### **Addendum 13: Global technical regulation No. 13**

#### **Global technical regulation on hydrogen and fuel cell vehicles**

## Global technical regulation on hydrogen and fuel cell vehicles

Figure X: Relationship between the initial burst pressure and end-of-life burst pressure (estimated)

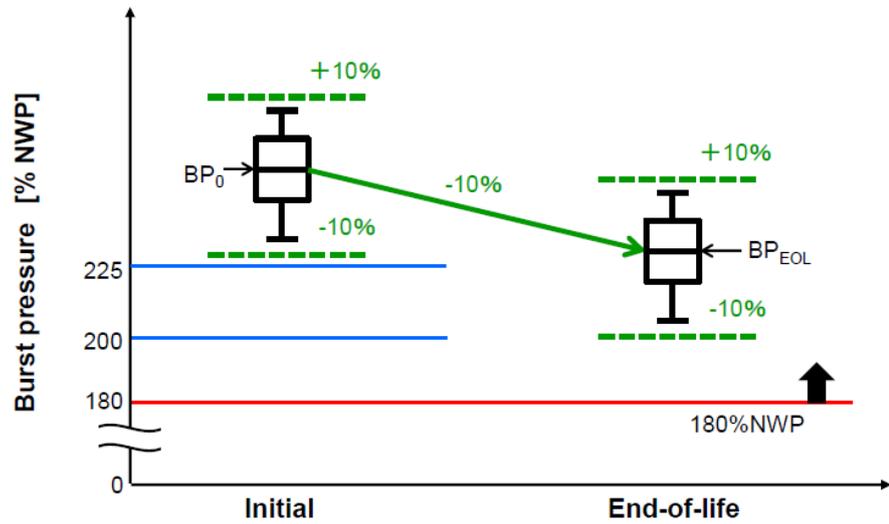
[In subsequent discussions of Phase 2, Japan presented data from experiments using carbon-fibre composite containers for 70 MPa, to support the minimum initial burst pressure change from 225 per cent NWP to 200 per cent NWP for carbon fibre containers only<sup>2</sup> \(Tomioka, J.](#)

The relationship between the current initial burst pressure requirement and the estimated end-of-life burst pressure requirement is shown in Figure X. The Japanese experiment showed that containers which met the  $BP_0 \pm 10$  per cent requirement and subjected to the hydraulic sequential tests, were able to meet end-of-life burst pressure of at least 180 per cent NWP, even if the minimum initial burst pressure is reduced to 200 per cent NWP.

The results show that the minimum initial burst pressure of 225 per cent NWP can be reduced to 200 per cent NWP while maintaining end-of-life burst pressure ( $BP_{EOL}$ ) above 180 per cent NWP and 80 per cent of  $BP_0$  requirements.

However, in Phase 2 discussions, another Contracting Party stated that the data to change the initial burst pressure requirement of the containers for 35 MPa is not sufficient. Therefore, the requirement value for the carbon-fibre composite containers for 35 MPa was left at 225 per cent NWP as a CP option with the expectation that additional data or analysis will become available in the future. While the minimum initial burst pressure of 200 per cent NWP for the carbon fibre containers is considered sufficient as a performance-based requirement for this GTR, the verification data are based on the tests with containers selected from a single batch. The production quality related to the variation between different production batches, etc. shall be recognized as the responsibility of container manufacturers.

Figure XXX:  $BP_0$  and  $BP_{EOL}$  Distribution

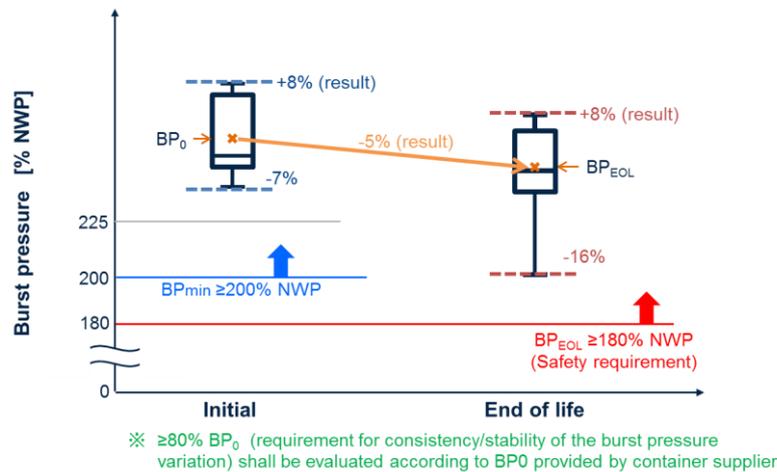
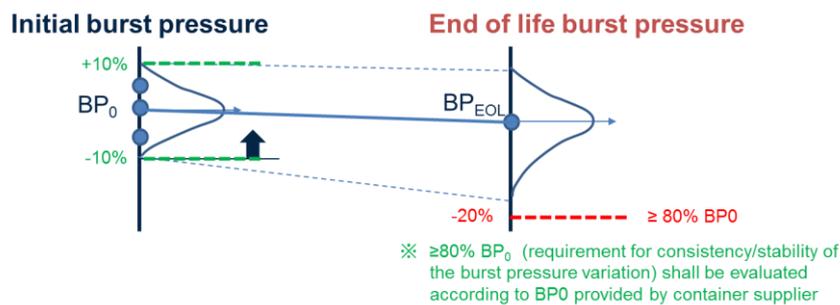
The test results are shown in Figure XX. The minimum value of the initial burst pressure was greater than 225 per cent, and within the  $\pm 10$  per cent of  $BP_0$  requirement. The end-of-life burst pressure, which takes into account the variation and degradation ratio due to testing, was greater than 180 per cent NWP. It was also greater than 80 per cent of  $BP_0$  by a sufficient margin (Figure XXX).
